Application for Licence Amendment

Licence Number	L8675/2012/1
Licence Holder	Millennium Minerals Pty Ltd
ACN	003 257 556
File Number	APP-0031951
Premises	<p>Nullagine Gold Project</p> <p>Mining Tenements M46/3, M46/47, M46/50, M46/57, M46/98, M46/129, M46/138, M46/146, M46/163, M46/164, M46/166, M46/167, M46/170, M46/182, M46/186, M46/192, M46/198, M46/199, M46/200, M46/225, M46/261, M46/262, M46/264, M46/265, M46/266, M46/267, M46/272, M46/273, M46/275, M46/276, M46/277, M46/278, M46/300, M46/432, M46/433, M46/434, M46/436, M46/442, M46/443, M46/444, M46/445, M46/545, G46/2, L46/33, L46/45, L46/88, L46/91, L46/98, L46/105, L46/115, P46/1755 and P46/1756</p> <p>NULLAGINE WA 6758</p> <p>As defined by the Premises map attached to the Revised Licence</p>
Date of Report	07/05/2026 (FINAL)
Proposed Decision	Intent to grant revised licence

Figure 1: Process Flow Diagram (elements in blue are proposed)

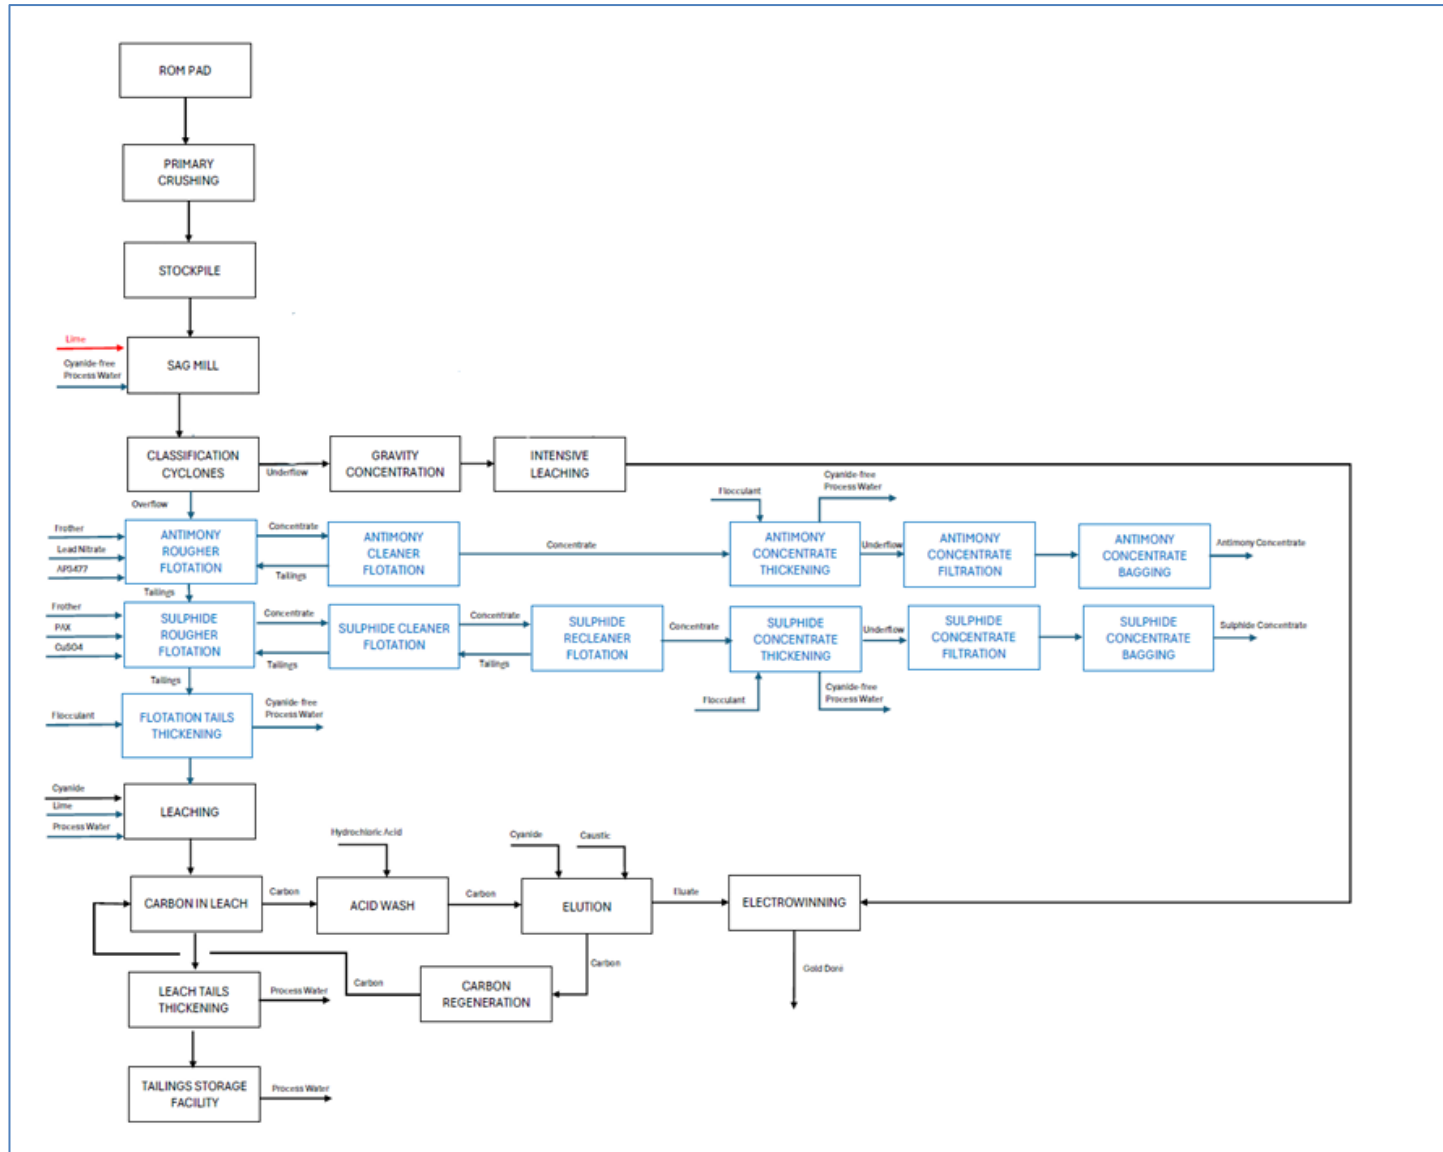
A two-part flotation circuit will be constructed to first extract a Stibnite (Antimony) concentrate prior to flowing down to the second stage of the flotation circuit to extract a sulphide concentrate as shown in Figure 1.

The Stibnite (or Antimony) flotation circuit will be constructed in front of the Sulphide circuit to enable the diversion of any Antimony rich ores through the Stibnite flotation circuit prior to running through the Sulphide component. This will allow the extraction of a Stibnite (or Antimony) concentrate using slightly different reagents than the Sulphide circuit.

The Stibnite flotation circuit starts with the slurry flowing through a rougher circuit comprised of up to five 19 m³ steel tank cells arranged in series. The tanks are open topped and designed for product to overflow out of top into a launder. The bulk of the slurry gravity feeds to the next tank which sits physically lower than the proceeding tank.

The Sulphide rougher flotation circuit shall be comprised of up to seven 100 m³ steel tank cells arranged in series. The tanks are open topped and designed for product to overflow out of top into a launder. The bulk of the slurry gravity feeds to the next tank which sits physically lower than the proceeding tank.

Condition	Summary of Licence Holder's comment	Department's response
Condition 7, Table 5 for the Flotation circuit	<p>The Licence Holder has stated -</p> <ul style="list-style-type: none"> • Stibnite flotation circuit - the rougher circuit will contain up to five 20 m³ open topped steel cells, not 19 m³. • Sulphide flotation circuit - the rougher circuit will contain up to seven 70 m³ open topped steel cells, not 100 m³. 	The department has updated the Licence as requested.
Condition 7, Table 5 for the Process Water Dam	<p>The Licence Holder has requested that the Process Water Dam be referred to as the Flotation Water Dam.</p> <p>The Flotation Water Dam is:</p> <ul style="list-style-type: none"> • Designed to be nominally 55 m (length) x 40 m (width) and 5.8 m (height), not 40 m (length) x 40 m (width) and 4 m (height). The 5.8m height includes the freeboard of 300 mm. • Capacity to hold 5,000,000 litres of water, not 6,400,000 litres of water. 	<p>The department has updated the Licence as requested.</p> <p>The Amendment Report has also been updated to now reference the Flotation Water Dam.</p>
